GULF STATES UTILITIES COMPANY

January 24, 1985
RBG- 19,971
File No. G9.5

River Bend Station-Unit 1
Docket No. 50-458

Enclosed is a revision to Chapters 13.1, 13.2, 13.4 and 13.5 of Gulf States Utilities Company (GSU) River Bend Station (RBS) Final Safety Analysis Report (FSAR). These revisions are the reflection of the organizational changes effective December 10, 1985 and will be incorporated into the next FSAR Amendment.

FIGURE 13.1-1

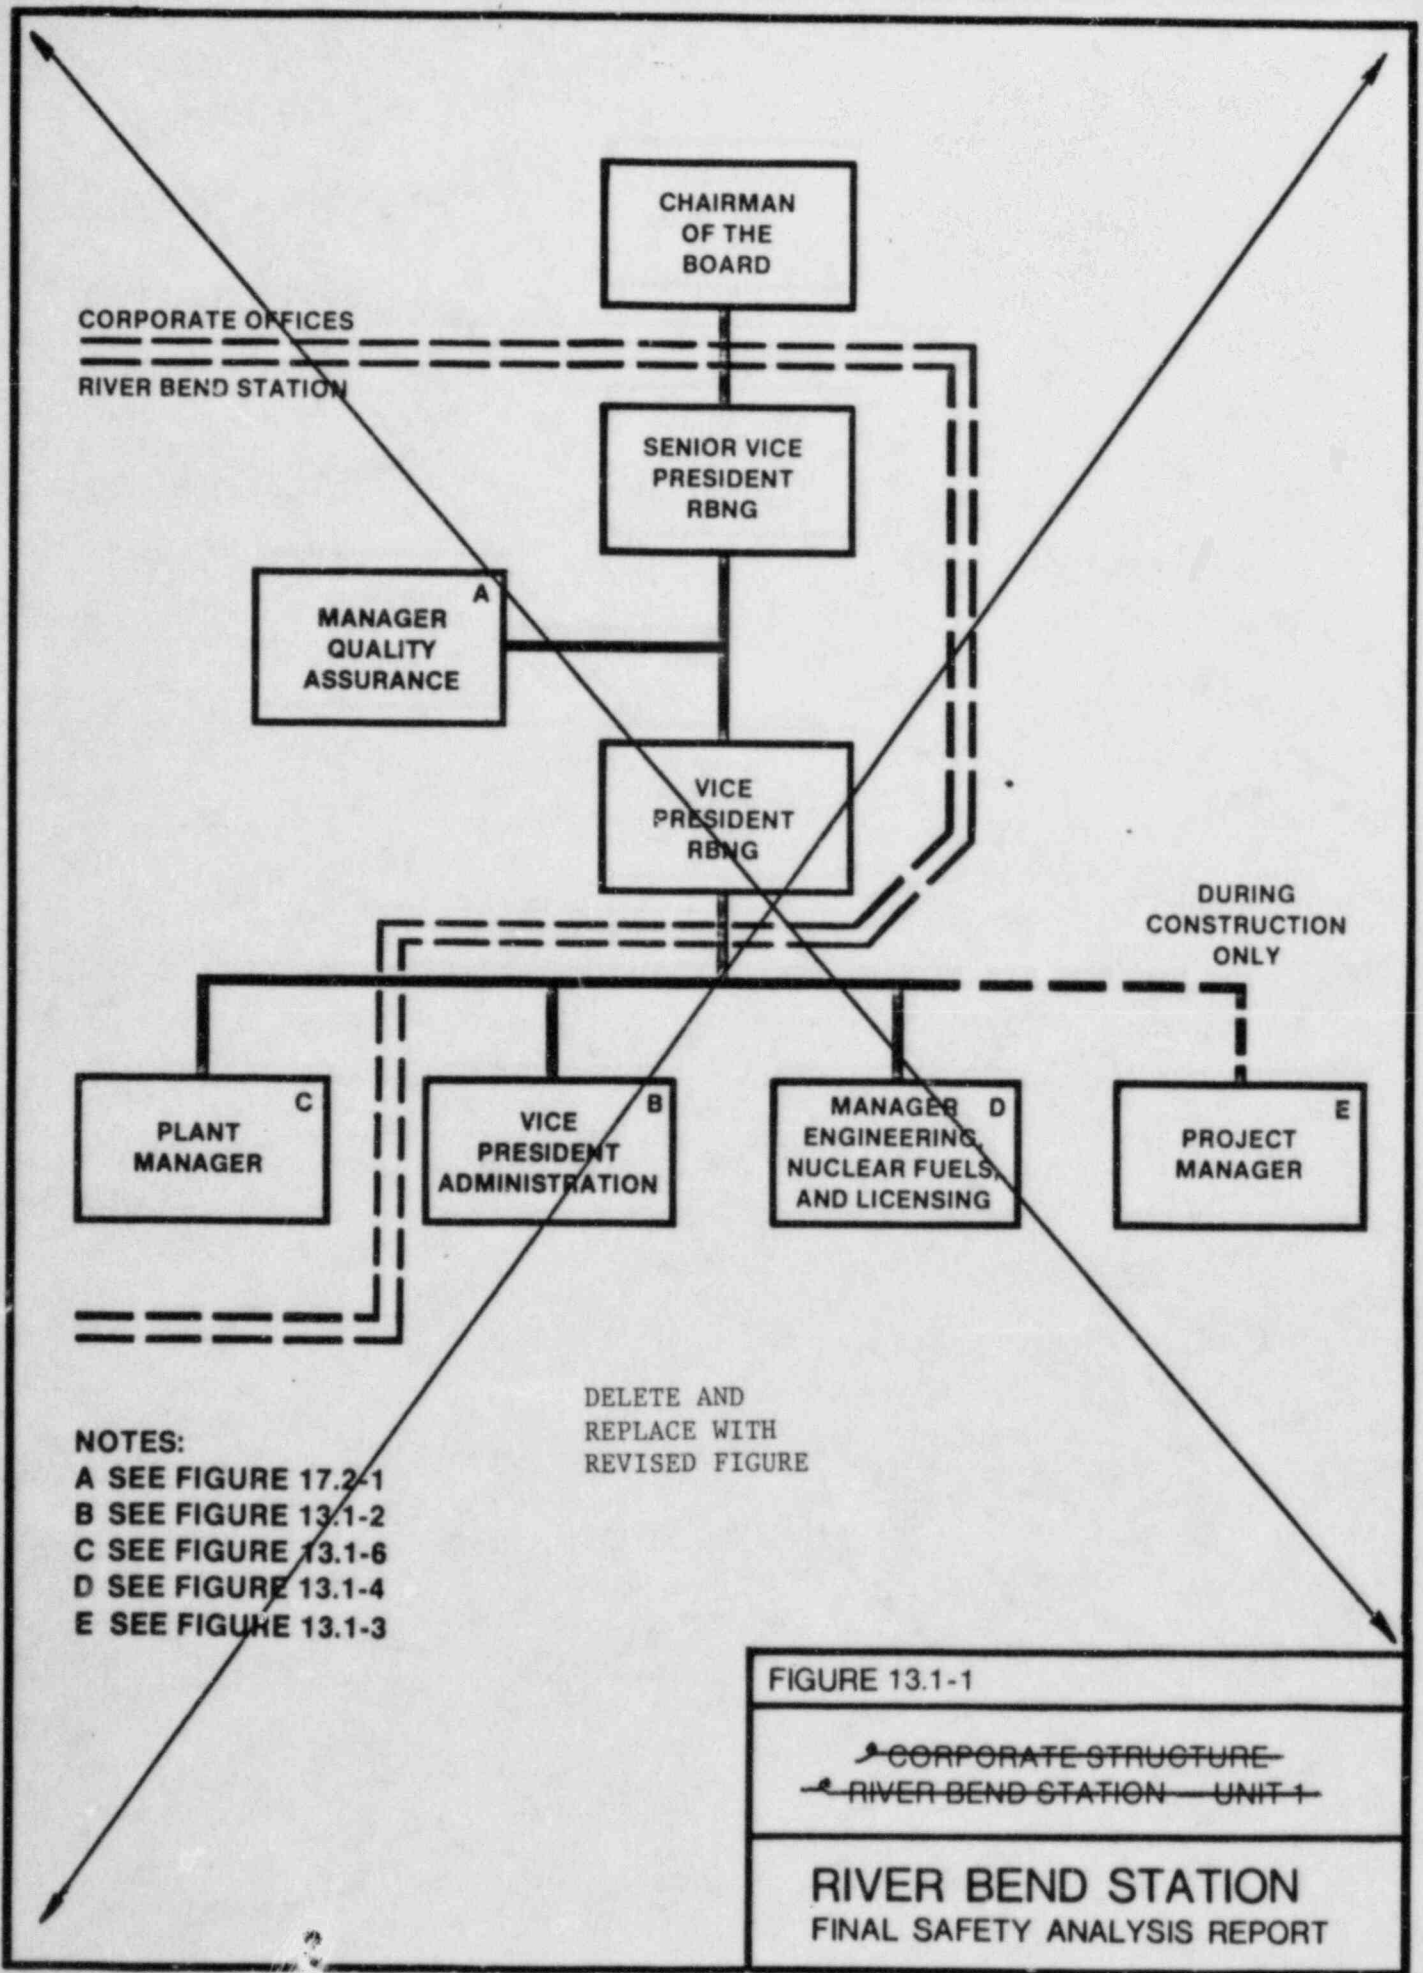
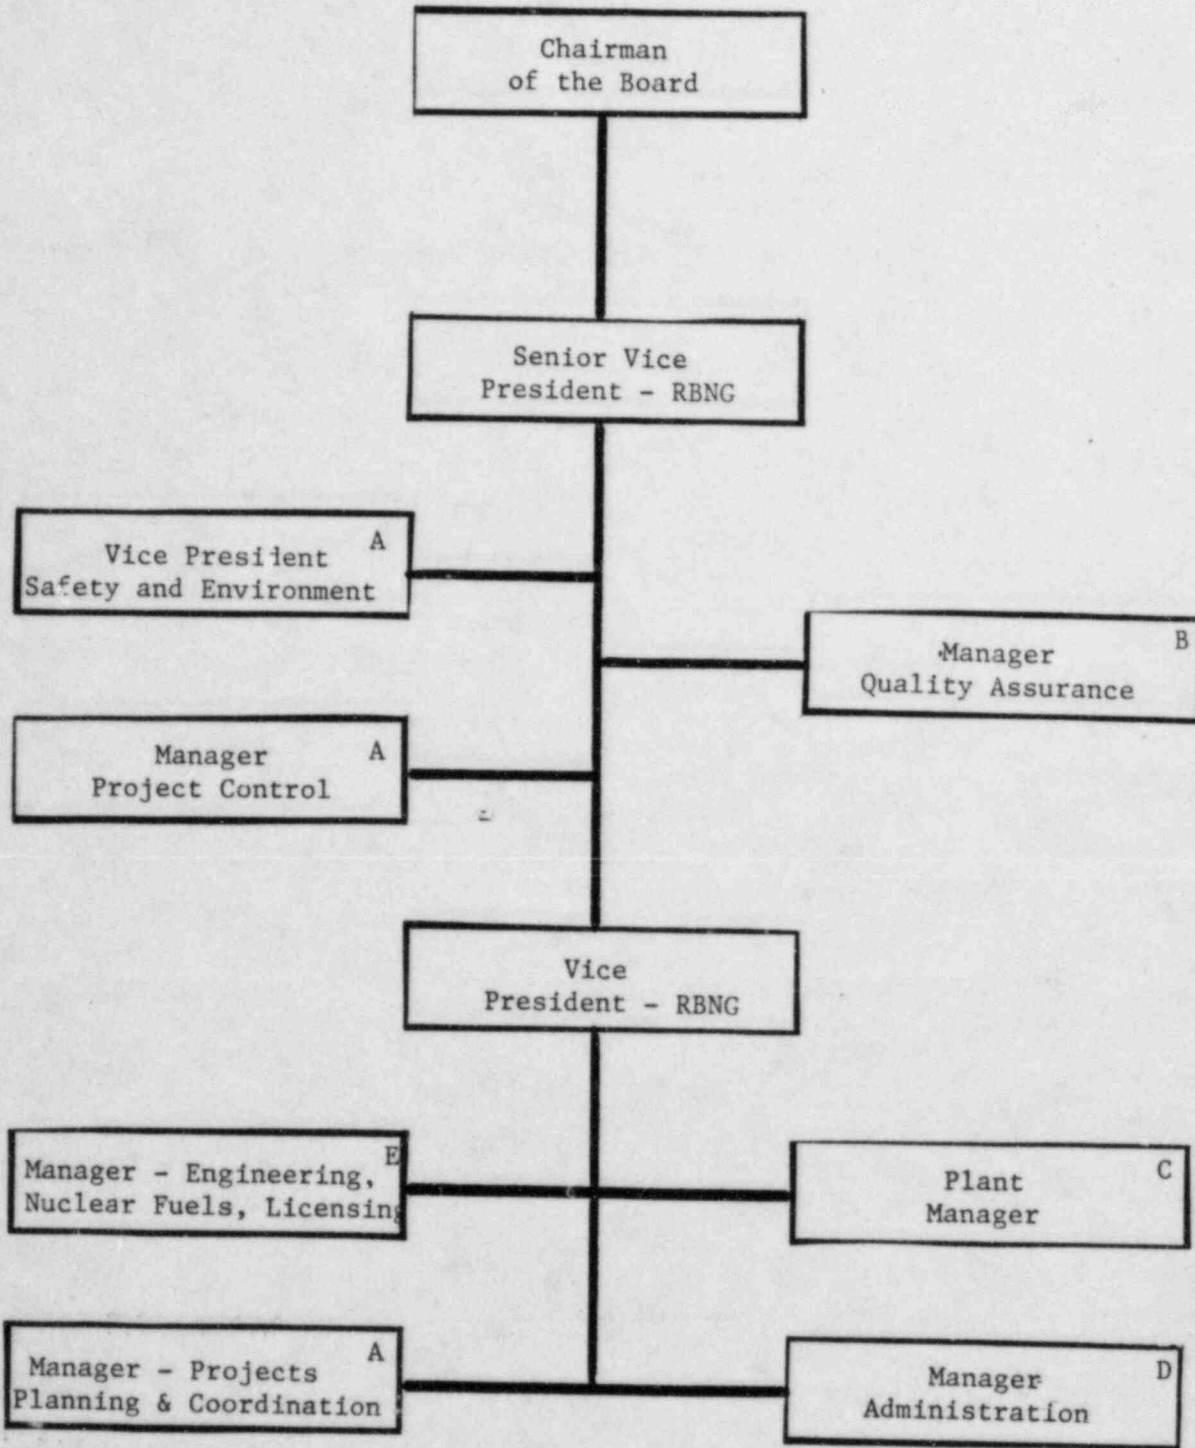
1. The titled position Project Engineer has been changed to Director-River Bend Projects. All duties and responsibilities remain the same.
2. The titled position Project Manager has been changed to Manager-Project Control. A new position of Manager-Projects Planning and Coordination has been created with responsibilities including the Director-River Bend Projects and his staff (Engineering) and the Director-Management System and his staff (Scheduling). These two responsibilities were formerly under the direction of the Project Manager. The duties associated with Startup and Test have been placed under the Plant Manager's organization. The duties of procurement have been placed under a new position, Assistant Plant Manager-Maintenance and Materials.

6. Individuals now reporting to the Senior Vice President-River Bend Nuclear Group (RBNC) include:
 - A.) Vice President-RBNG
 - B.) Manager-Quality Assurance

- C.) Manager-Project Control
 - D.) Vice President-Safety and Environment

Figure 13.1-1
River Bend Nuclear Group
Management Structure

FIGURE 13.1-1a
CORPORATE STRUCTURE- GULF STATES UTILITIES COMPANY
RIVER BEND STATION FINAL SAFETY ANALYSIS REPORT

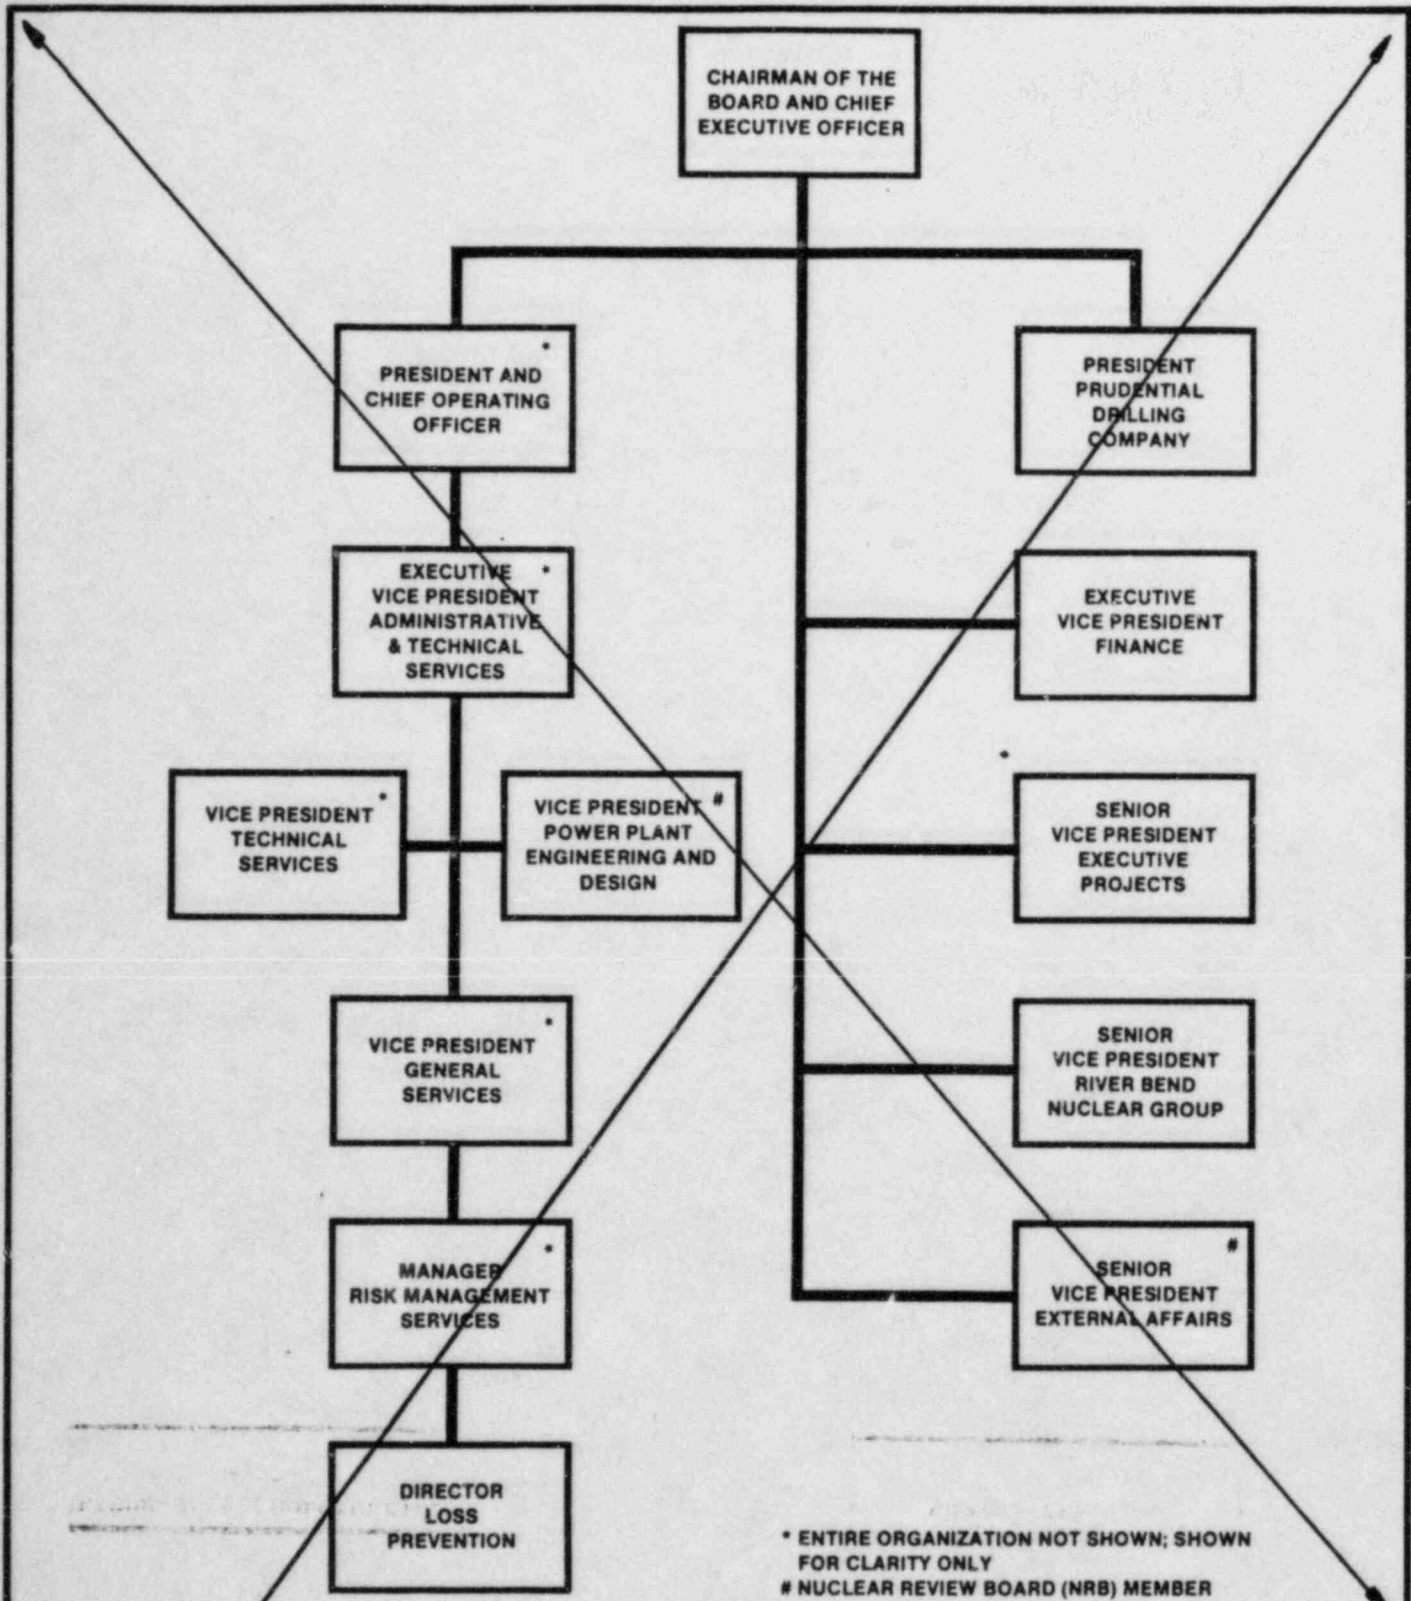
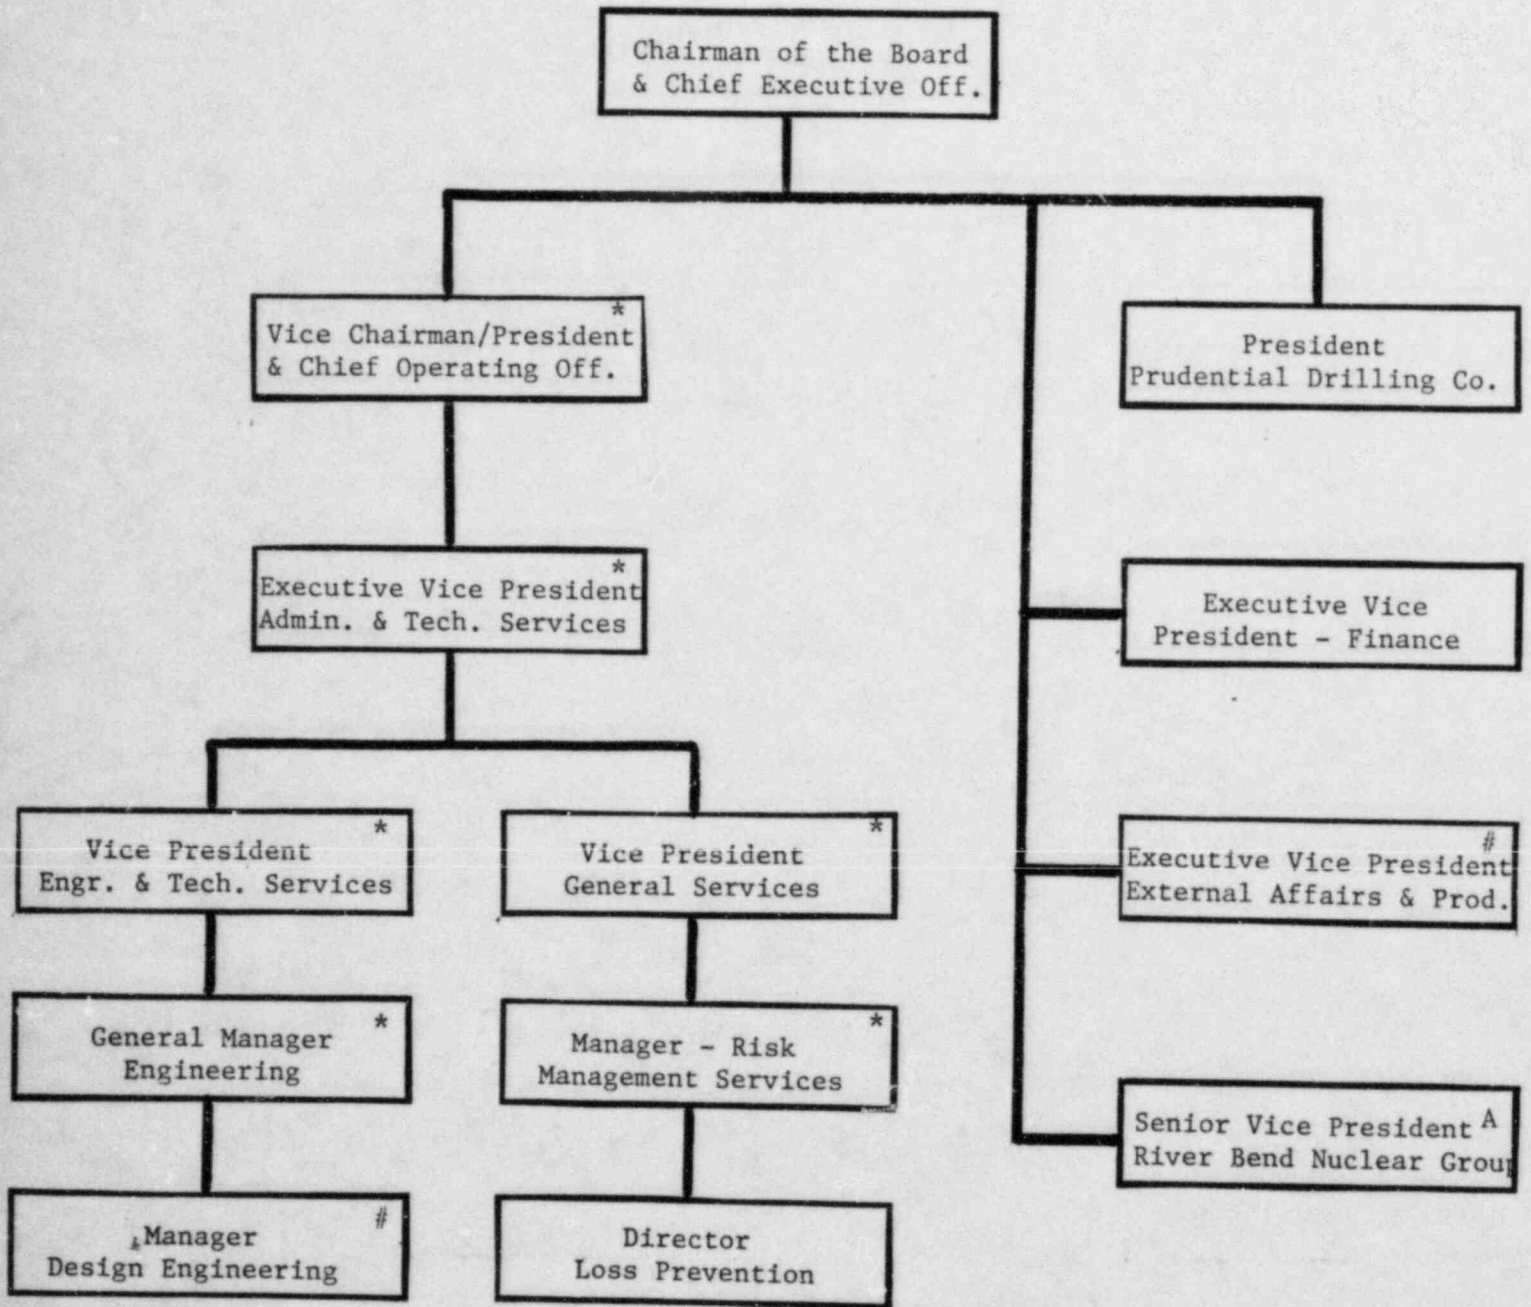
5. The groups outside of River Bend Nuclear Group but still within Gulf States Utilities Company which are generally available for support have been merged together. The Power Plant Engineering and Design Group and the Department of Technical Services now exists as the Department of Engineering and Technical Services retaining all former responsibilities. In addition, the Manager-Design Engineering has replaced the Vice President-Power Plant Engineering and Design on the Nuclear Review Board.

DELETE AND REPLACE WITH REVISED FIGURE

Figure 13.1-1a
Gulf States Utilities Company
Corporate Structure

FIGURE 13.1-2
~~PLANT ADMINISTRATIVE STRUCTURE~~
~~RIVER BEND STATION — UNIT 1~~
RIVER BEND STATION
FINAL SAFETY ANALYSIS REPORT

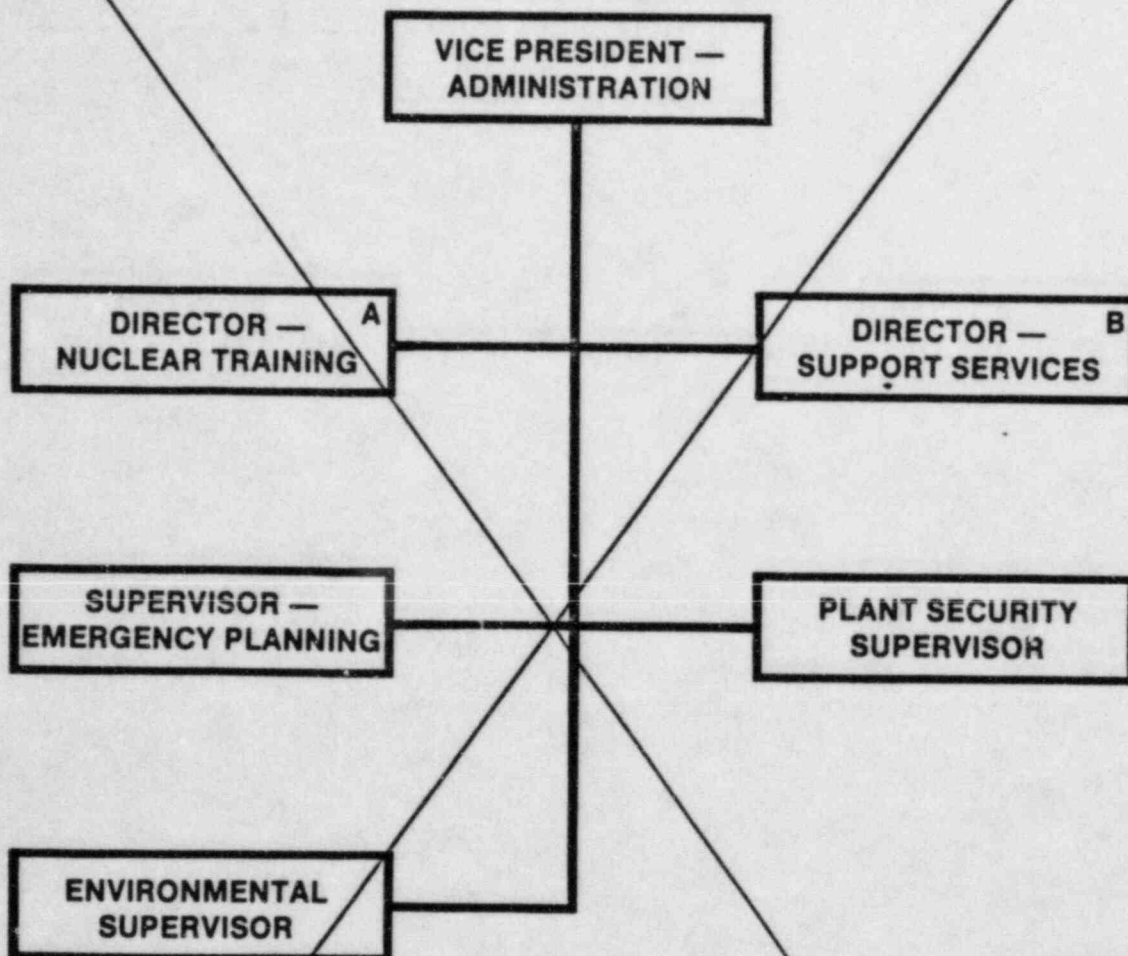
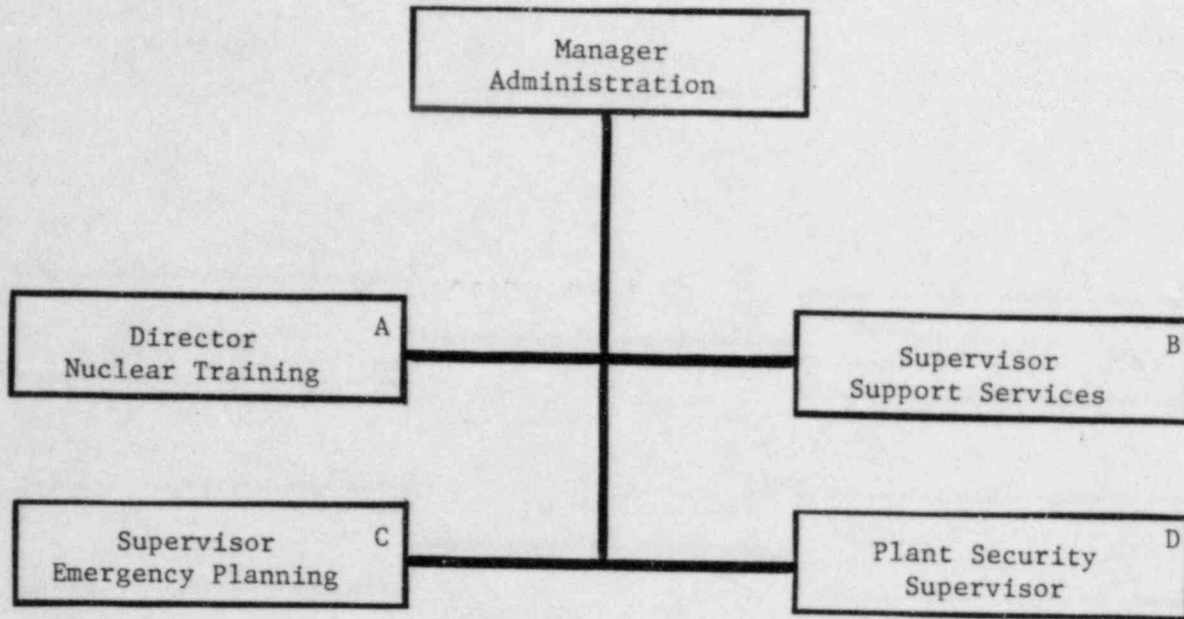
8. Individuals now reporting to the Vice President-RBNG include:
 - A.) Plant Manager
 - B.) Manager-Engineering, Nuclear Fuels and Licensing
 - C.) Manager-Projects Planning and Coordination

- D.) Manager-Administration
9. Regarding the Plant Staff organization three Assistant Plant Managers (APMs) and the new position of Supervisor-Radiological Programs report directly to the Plant Manager. The Supervisor-Radiological Programs replaces the Radiation Protection/Chemistry Supervisor and retains all responsibilities except for sampling and analysis of plant fluid systems. The function becomes part of the Chemistry Section which along with Operations and Radwaste report to the APM-Operations, Radwaste and Chemistry. Still reporting to the APM-Technical Services is the Technical Staff and the Plant Services Group. This latter group replaces the Technical Materials and Plant Services Group and retains all responsibilities except for materials controls. Purchasing and materials duties are now under the direction of the Assistant Plant Manager - Maintenance and Materials along with general maintenance functions (see Item 4 above.)

DELETE AND
 REPLACE WITH
 REVISED FIGURE

Figure 13.1-2
River Bend Nuclear Group
Administrative Structure
